PUBLIC UTILITIES COMMISSION OF THE STATE OF CALIFORNIA

RESOLUTION E-5150

Resolution E-5150. Adopts updates to the Avoided Cost Calculator for use in demand-side distributed energy resource cost-effectiveness analyses.

Figure 1: Joint Utilities analysis of average avoided costs, based on seven ACCs from 2004 to 2021 (Figure 6 in the Joint Utilities’ comments).

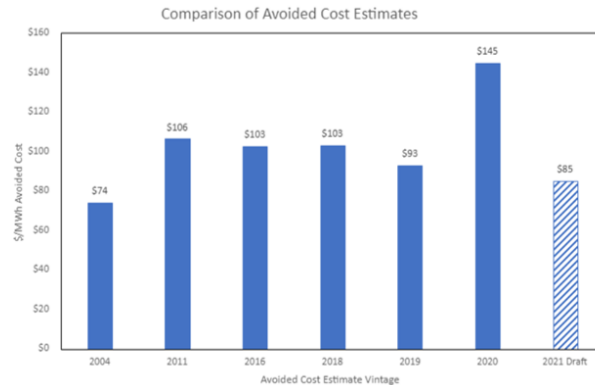
The Joint Utilities state that the proposed 2021 ACC results are reasonable and an improvement from the 2020 ACC because errors were corrected as a result of

modeling updates. In particular, SERVM output was improved by benchmarking and changes to the scarcity adjustment algorithm, which the Joint Utilities say “is a minor update because it adjusts relatively few high-priced hours in the forecast.” They also point out that avoided costs have been relatively stable over the years, and that they argue that the 2020 ACC results were unusually high, as shown in the figure below⁹.

TURN also states that their review of the comments reinforces their conclusion that none of the parties “even alleged that the outputs of the 2021 ACC were less accurate or realistic than the outputs of the 2020 ACC.” They argue that “what is obvious from the intervenor comments is that the Commission’s first attempt at integrating the IRP and the ACC in 2020 resulted in some obvious errors in the results,” and cites the graph provided by the Joint Utilities and NRDC shown in Figure 1.

Figure 3: Slide 12 of the presentation made at the IDER workshop, December 9, 2020

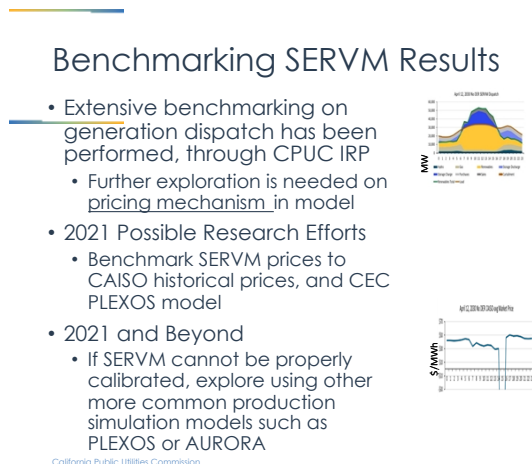
(7) Energy Division staff’s presentation at the December 2020 workshop implied that changes discussed in the early part of the workshop were all proposed for the 2022 major update, because 2021 minor changes weren’t discussed until later in the workshop.

Energy Division staff did not state that changes discussed in the early part of the workshop were all proposed for the 2022 major update, and we are unaware of how that could have been implied. In fact, one of the slides from the early part of the workshop discusses one possible 2021 change, as shown in Figure 3 below.
